**AGENDA
FARRAGUT MUNICIPAL PLANNING COMMISSION**

**April 18, 2019
7:00 p.m. Farragut Town Hall**

**MINUTES
FARRAGUT MUNICIPAL PLANNING COMMISSION**

SUBJECT: Discussion of preliminary plans for Union Road, from N. Hobbs Road to Everett Road

PLAT

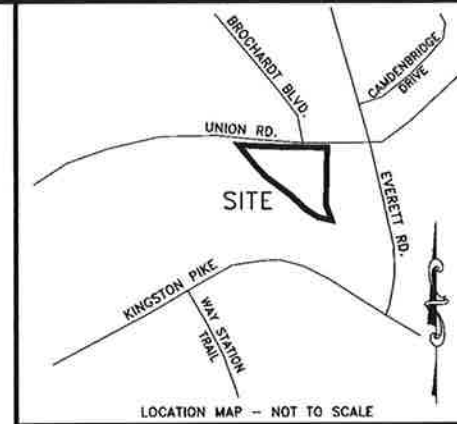
1. Please add on the final plat application the request for a variance from the requirement to construct a pedestrian facility along the property's Union Road frontage. The FMPC must specifically take action on this request prior to taking action on the plat;

2. Since this is a proposed new lot and not a lot in existence prior to the adoption of the Aquatic Buffer Ordinance, it is not exempt from the ordinance. Please have a **recognized wetland determination specialist** provide a written determination as to whether the property has any jurisdictional wetlands. Staff noted in a previous review that (based on field review) the property appears to have wetland characteristics but this would only be something that a qualified expert could determine for certainty;

3. Please add the standard explanatory Aquatic Buffer note;
4. Please define B.F.E. and M.F.E on the plat. We need to assure that all future property owners see and understand the notations on the plat;

5. Staff's previous comments questioned the anticipated area of disturbance. Apart from note #13 this does not appear to have been addressed. In addition, the location of a future driveway with respect to Brochardt Boulevard must be evaluated (it will ultimately have to be approved by both the FMPC and the FBMA) for purposes of future compliance prior to any approval of the plat;

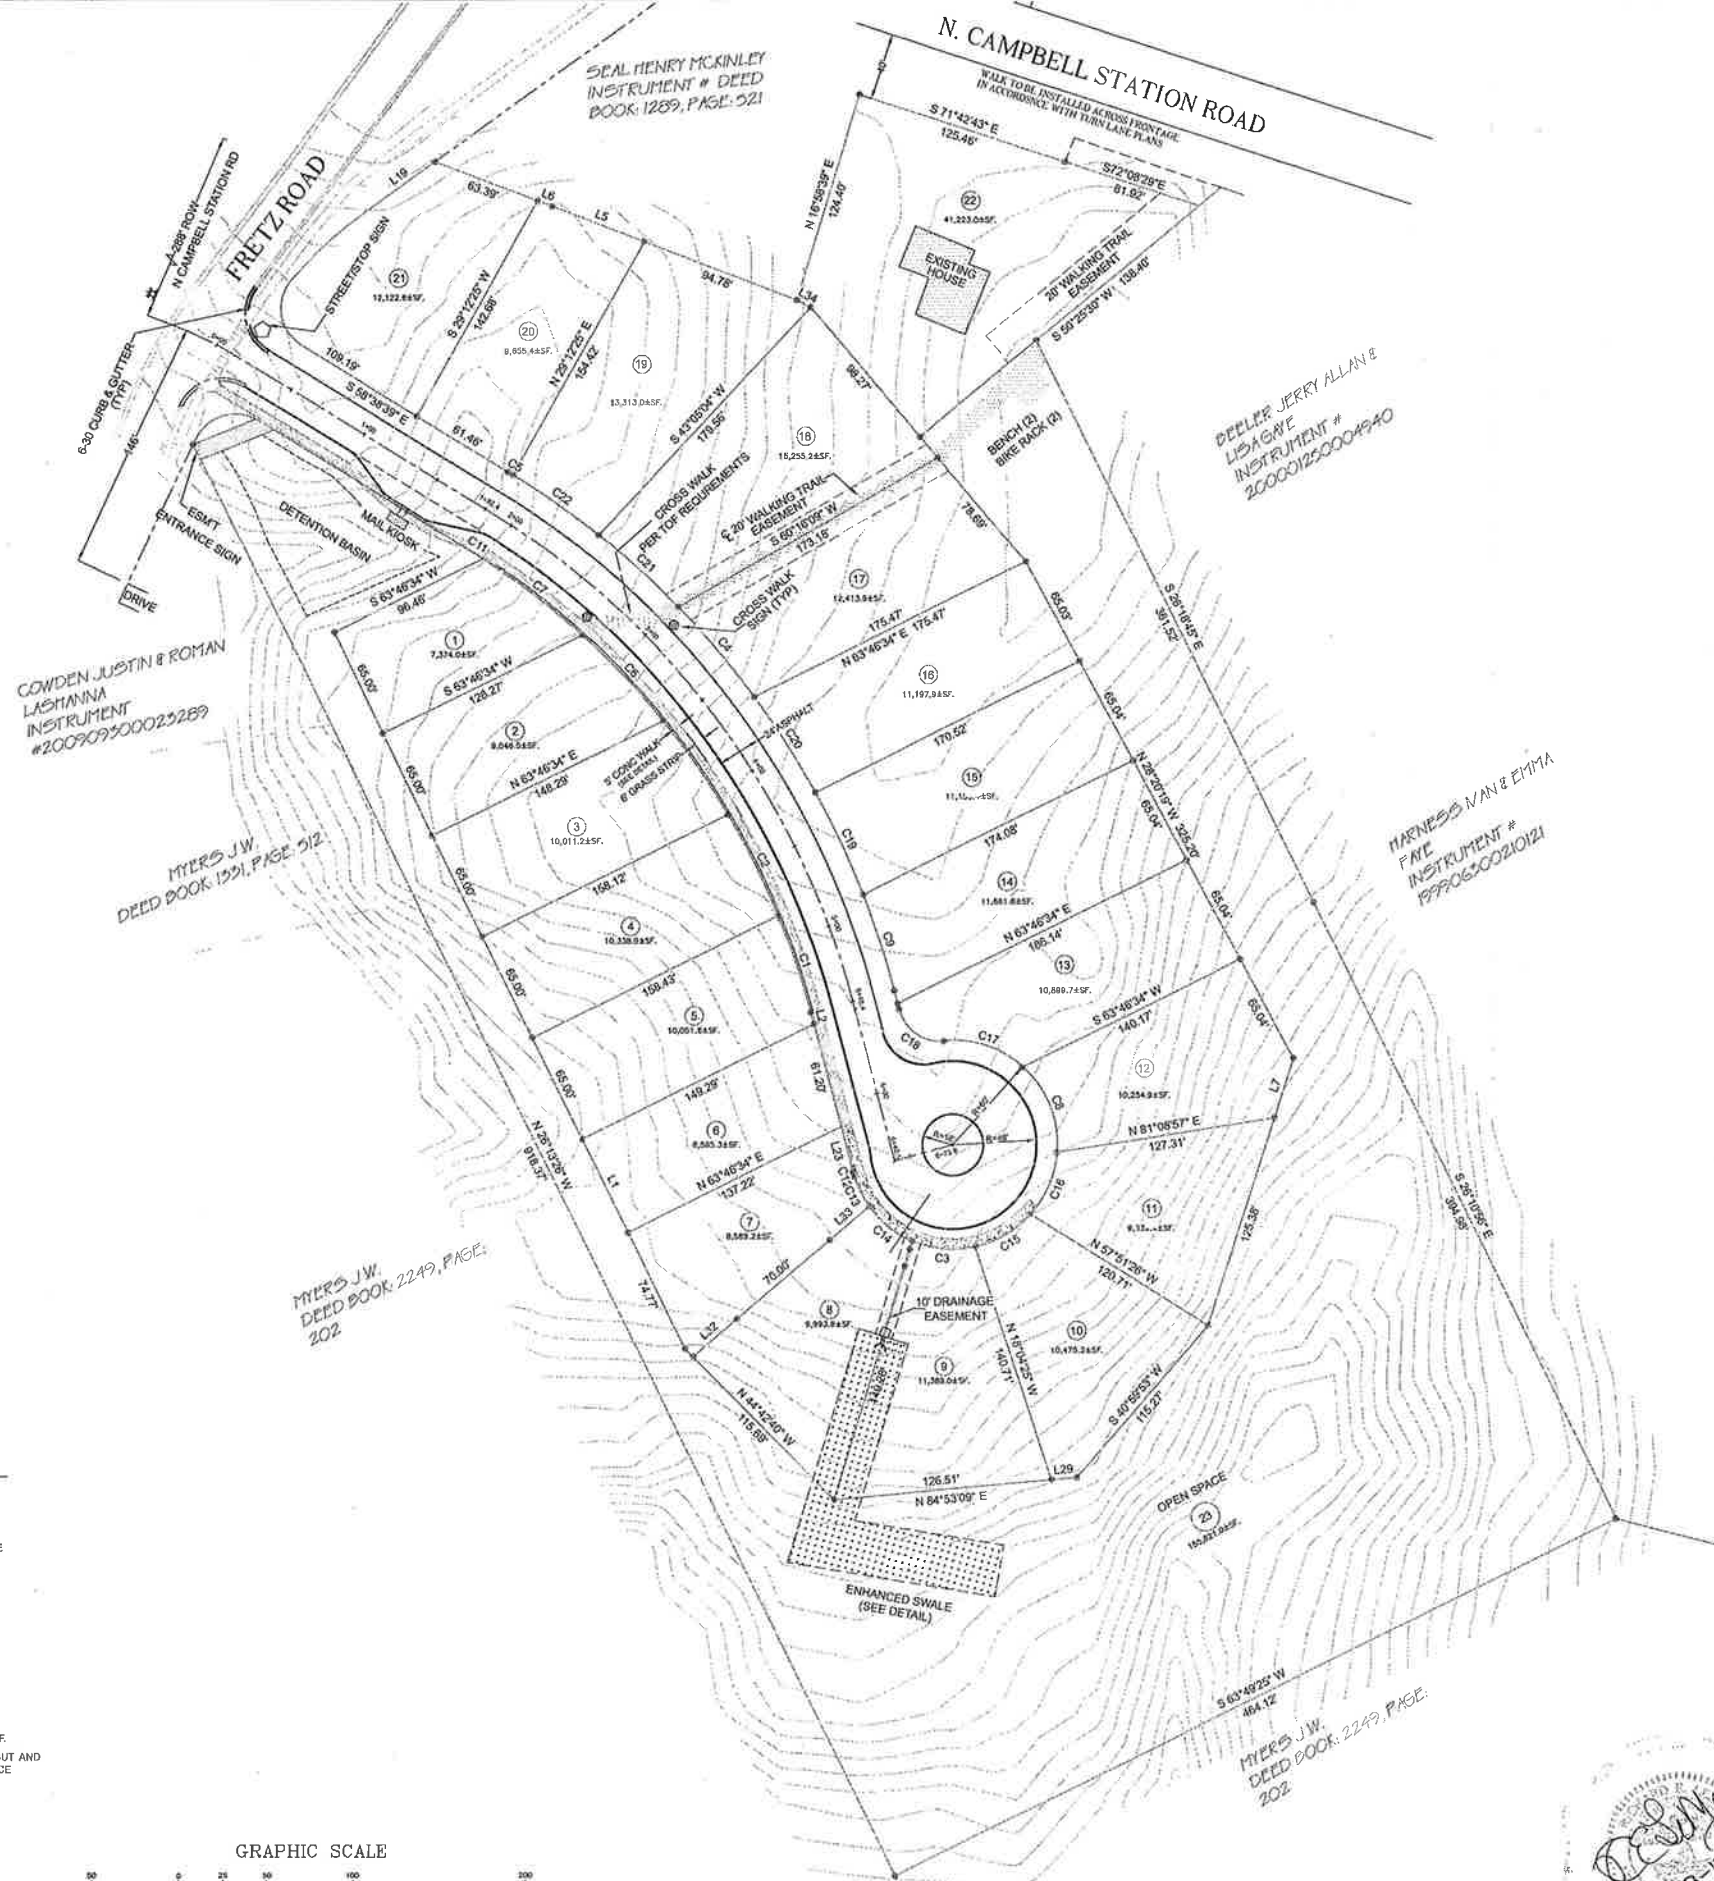
- 1) Please provide the required ROW width of Fretz Road across the entire frontage;
- 2) Note # 14 does not include crosswalk signs. Please include if they will be required (verify with Eng. Dept.);

- 4) The enhanced swale drainage area is shown differently (size & shape) on various sheets. Please explain and/or correct. The area also appears to be located on both the open-space lot and lots 8 & 9 on some sheets. Please discuss any proposal for locating this type of facility on individual lots with the Town staff;

- 5) The enhanced swale detail referenced on the preliminary plan sheet is located on the detail sheet for the separately submitted SWPPP plan sheet set. The detail should be included with the preliminary plat sheets or better yet the SWPPP sheets should be combined with the preliminary plan/plat sheets into a single submission set;

- 6) The seal on the tree protection & replacement plan sheet does not appear to be properly signed (the date is below the seal). Please review and correct;

- 7) The streetscape plan sheet has not been sealed;
- 8) The location of the sign and surrounding area on the streetscape sheet does not appear to be consistent with the same area on the preliminary plan sheets. Please correct;

- 10) Please provide revised drainage calculations that address the following:
 - a. Calculations for the bioretention swale
 - b. Elevations/dimensions for outlet structure match what is shown on the plans

- 12) All stormwater pipes should be RCP;
- 13) "K" value for 35 mph design speed for crest and sag vertical curves are 29 and 49, respectively;
- 14) Please provide detail for street name sign. It shall include all current MUTCD standards with regards to size, upper and lower case letters, reflectivity, etc.;

- 15) Please provide grading plan for Sediment Basin #2 and the bioretention swale on the plan sheets of the SWPPP;
- 16) Please submit NOC;
- 17) Please provide an irrevocable letter of credit for erosion control for \$53,000; and

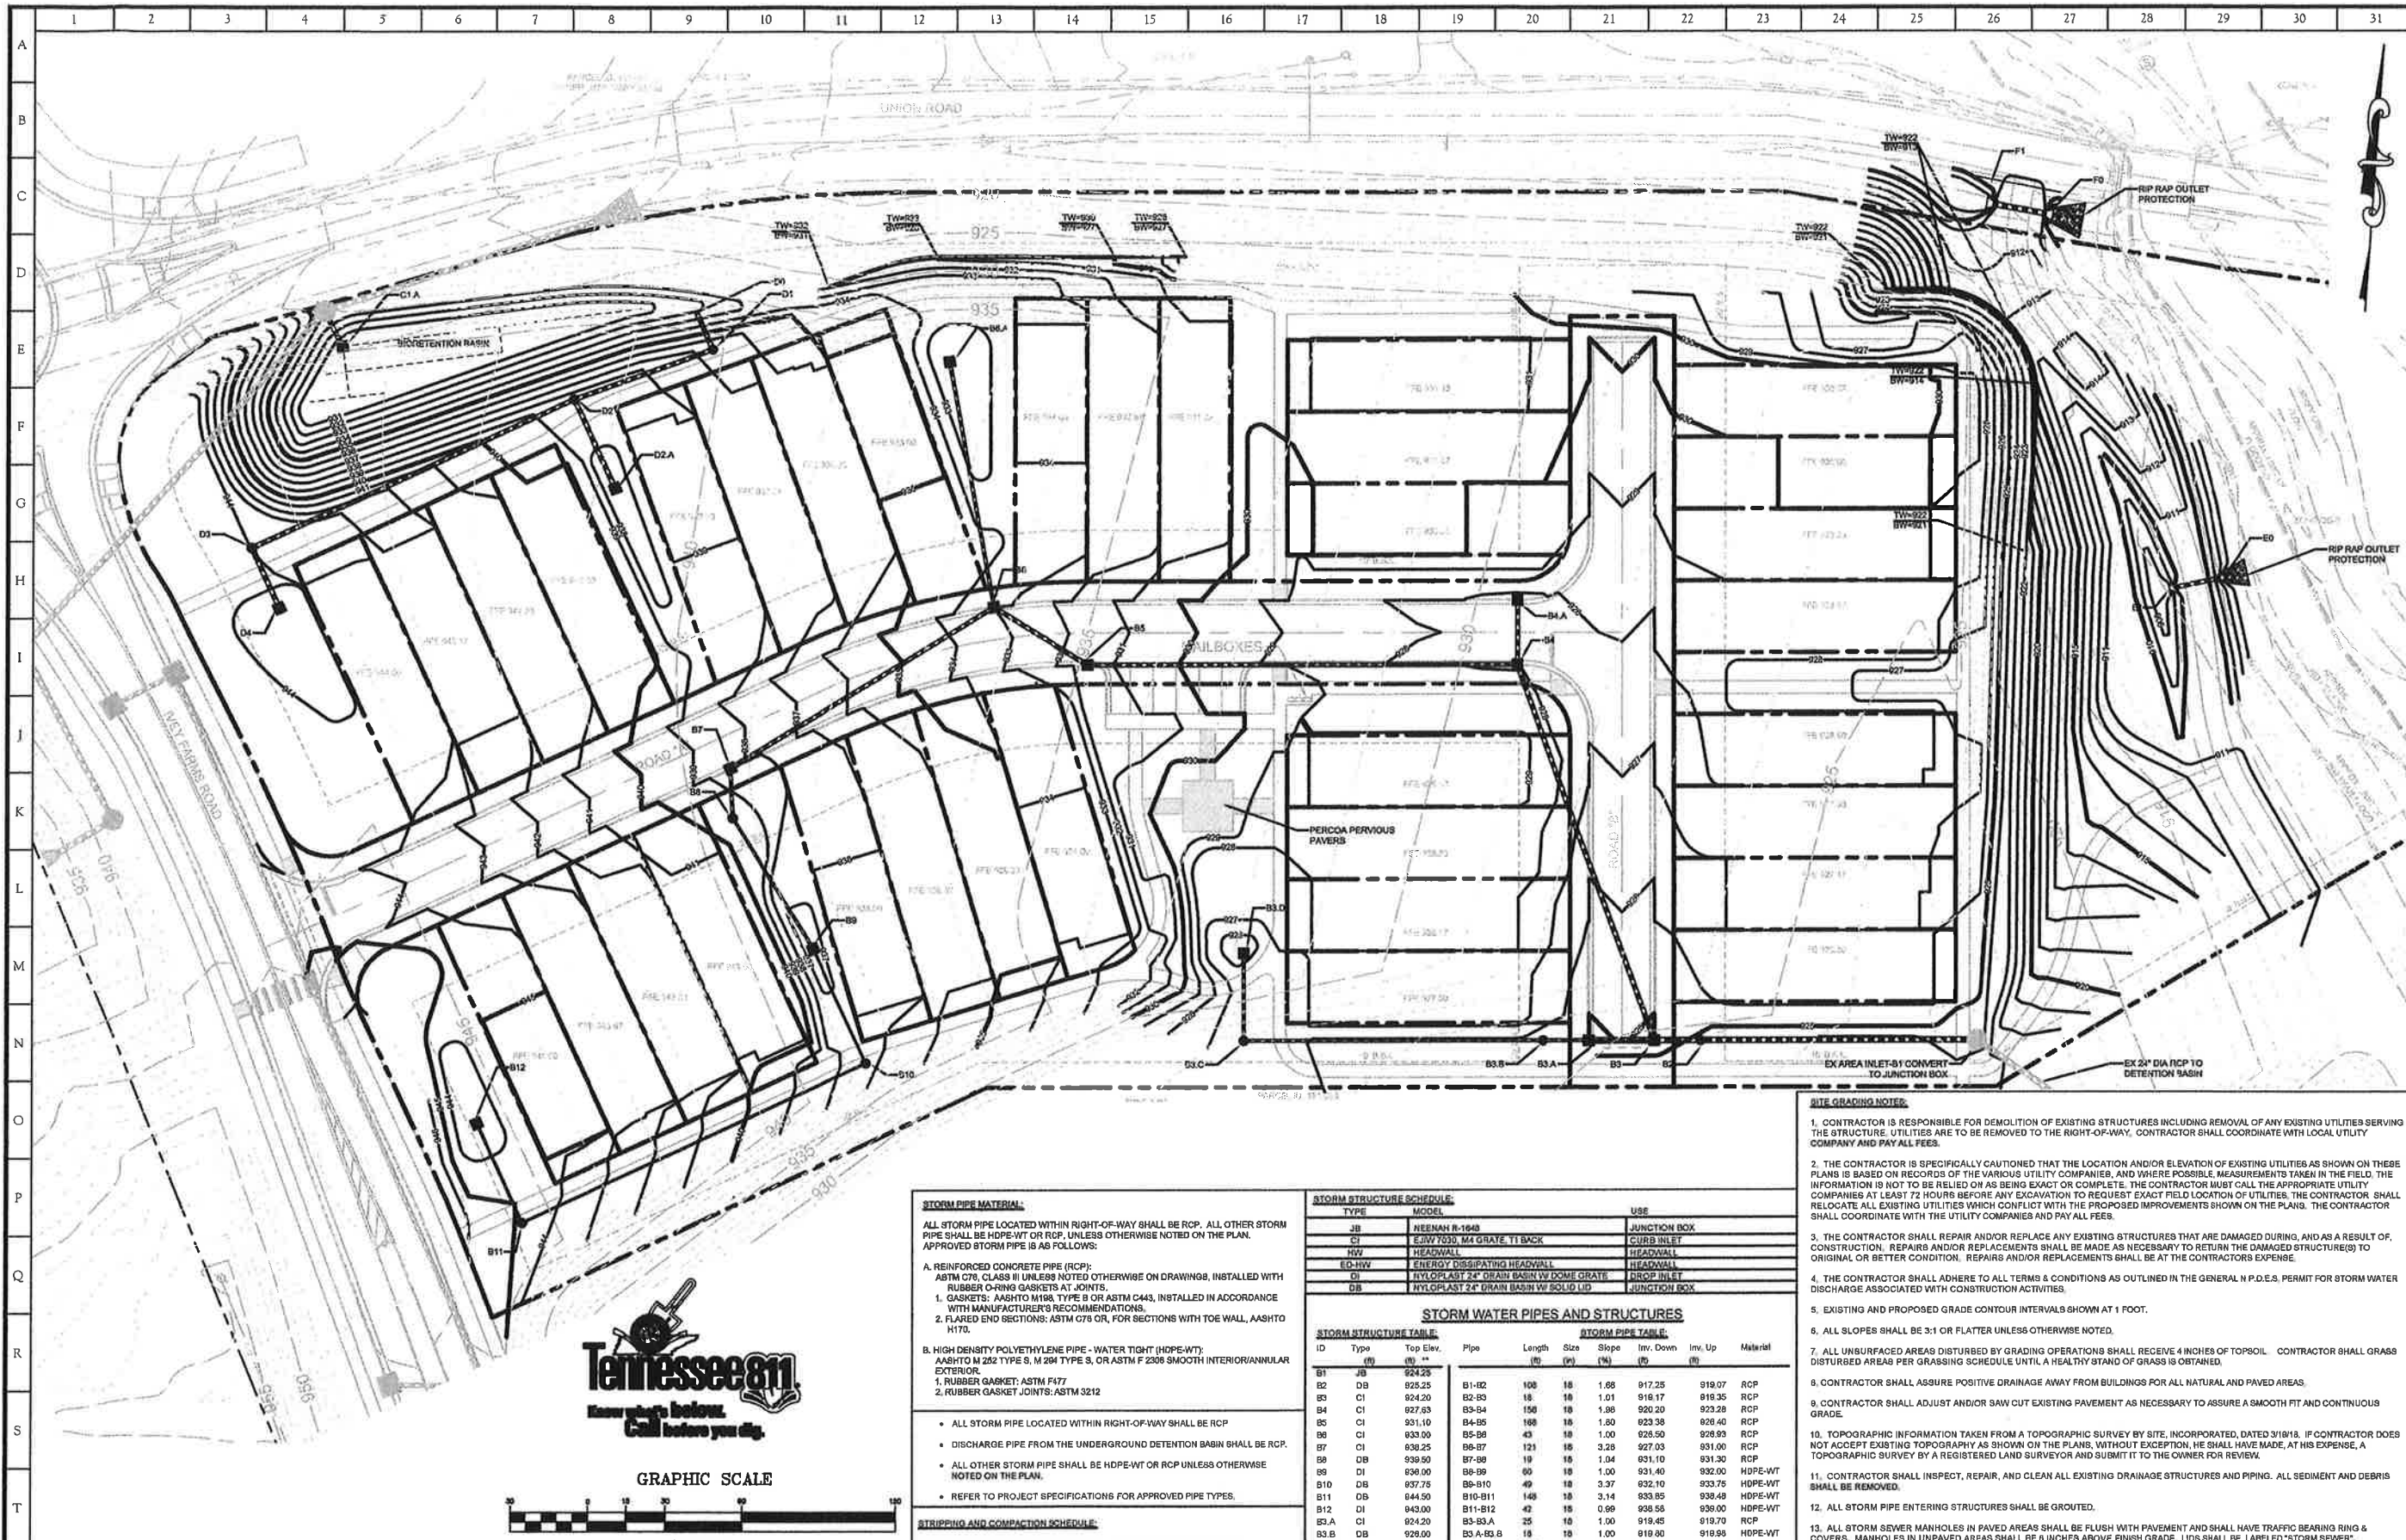
1. Please review the “purpose of the plat” note and modify as needed.
2. Please clarify on the plan sheets that this is a portion (7.11 ac) of the larger Swan Farm (which has not yet been divided). Please also clearly note on the plan that the plan/plat for Ivey Farms Road has not yet received final approval and that approval of this development is linked/contingent on such final approval.

3. Please provide lot coverage calculation for the development.
4. Please include the approximate acreage of the individual lots being created.
5. Please include the setbacks, front and back, for the proposed buildings on the individual lots. The typical building envelope indicates 20 and 10 feet. The distance between the front building façade and sidewalks needs to be evaluated and ultimately assured.

9. A sidewalk connection should be planned from the walking trail/sidewalk near the southeast corner of the lot 23 into the commercial development to connect with the planned commercial development to the south (see concept plan sheet).

10. Please discuss the streetscaping and landscaping plans with Staff. We would like to see the streetscaping enhanced as much as possible given the limited space, and also ensure that the new residential neighborhood is clearly demarcated/separated from the proposed commercial areas to the south.

11. Please update and include all relevant Tree Preservation and Removal Plan sheets from the larger Ivey Farm Road and mass grading Plat/Plan.
12. Please clarify the Road A typical Cross Sections for sidewalk vs non-sidewalk areas. Please do the same for Road B to indicate greenspace strip areas.

UNION ROAD
TANGENT SECTION
N.T.S.
FROM STA. 9+99.90 TO STA. 15+47.12

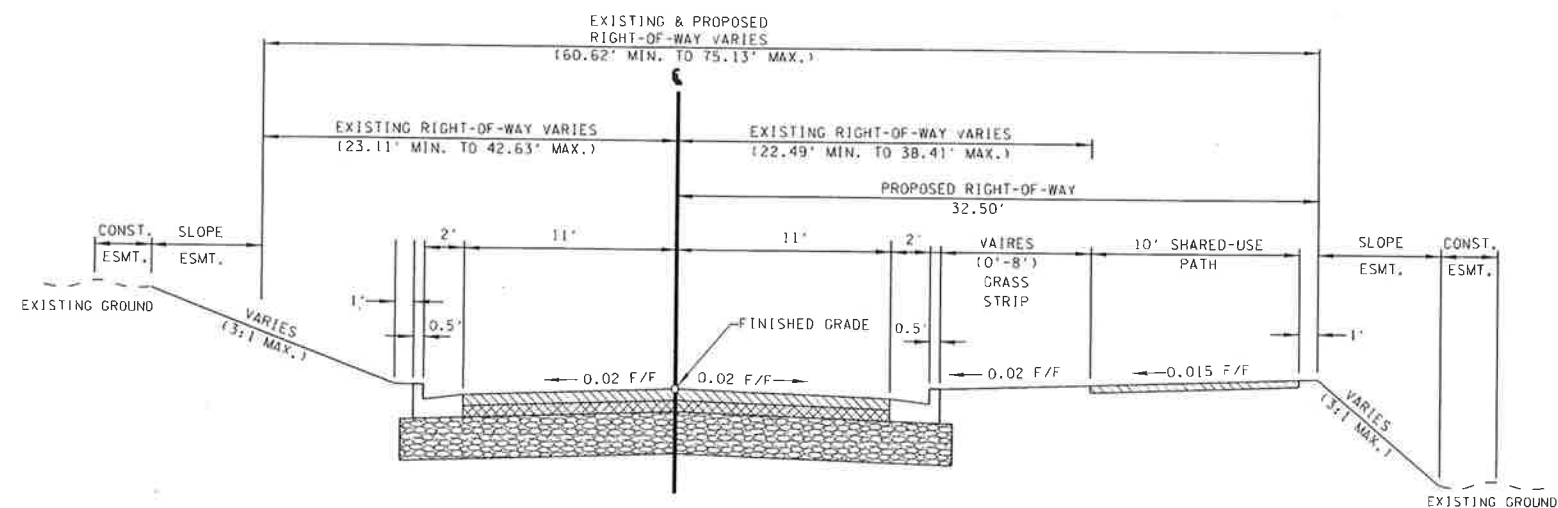
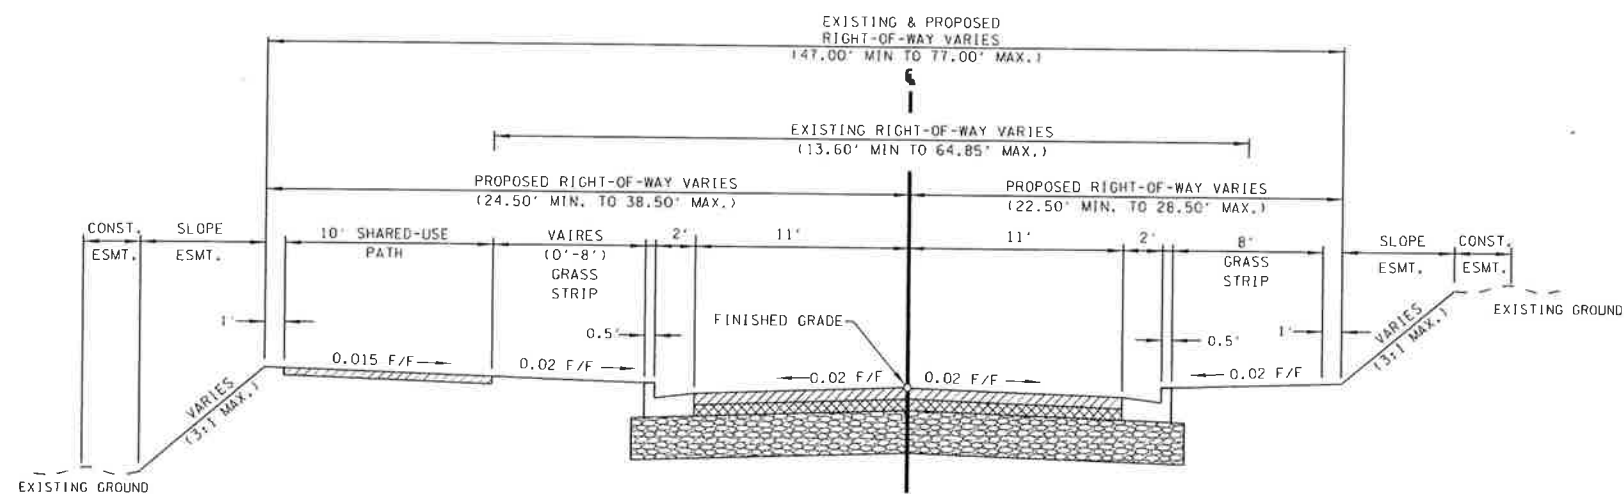
The current design plans include two 11-foot lanes with curb & gutter (2-1/2' wide, to avoid wide paved shoulders), an 8-foot grass strip and 10-foot shared-use path. Please note that the 8-foot grass strip is proposed instead of the typical 6-foot width in order to provide for the planting of trees between the roadway and path, further improving aesthetics and providing lateral offset from vehicular traffic.

width of 12-feet (See Exhibit 2 & 2B), a design exception was obtained for this project to reduce the lane width to 11-feet to decrease impacts to property owners along Union Road. The Town has had a long-term goal for over two decades to promote bike and pedestrian connectivity throughout the Town, starting with the Town's Pedestrian Circulation Plan drafted in October 1997 (See Exhibit 3). The street section currently proposed for Union Road (two 11-foot lanes, curb and gutter, an 8-foot grass strip, and 10-foot multi-use path) meets those goals and provides a safe, bike and pedestrian-friendly connection for residents along the route. Additionally, the inclusion of a multi-use path on one side of the proposed Union Road allows both bicyclists and pedestrians to use the path. Five-foot sidewalks are not wide enough for two-directional bicycle and pedestrian use (See Exhibit 1 & 4), so the multi-use path eliminates the need for bike lanes in the street section, which would include an additional eight feet of pavement to provide for two, four-foot bike lanes (See Exhibit 5, 6 & 7). Per the adopted complete streets plan, the multi-use path and corresponding green space will remain at widths of 10-feet and 8-feet, respectively.

- **Reduce the overall width of the multi-use path and green strip.** The minimum width for multi-use paths is 10 feet, per Tennessee Department of Transportation (TDOT) requirements (See Exhibit 5). As this project is funded with 80% federal/20% local dollars, design parameters are required to follow TDOT requirements. The width of the grass strip between the back of curb and the edge of the greenway can vary somewhat by TDOT standards, but the Town requires a minimum width of 6 feet on roadways classified as collectors (See Exhibit 8). For Union Road, however, the Town plans on planting street trees within this grass strip, requiring a minimum of 8 feet of width for proper development of those trees.
